## Flamanville 3 EPR

Safety assessment and on-site inspections

# **Lack of reinforcement in the nuclear island basemat**

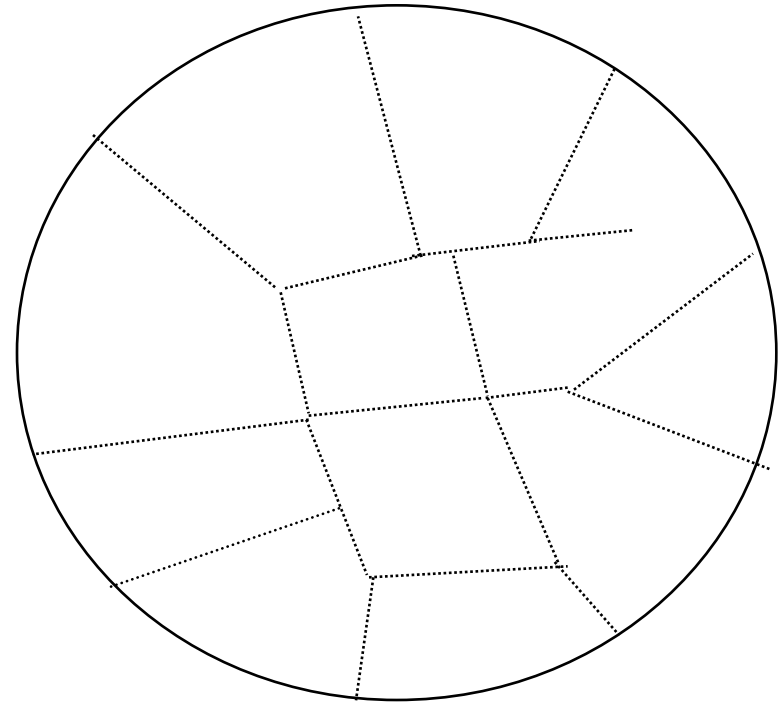
Noticed during the inspection of block number 2 of the fuel building while the concreting was in progress.

The concreting work was rapidly stopped and resumed only after the reinforcement was completed.
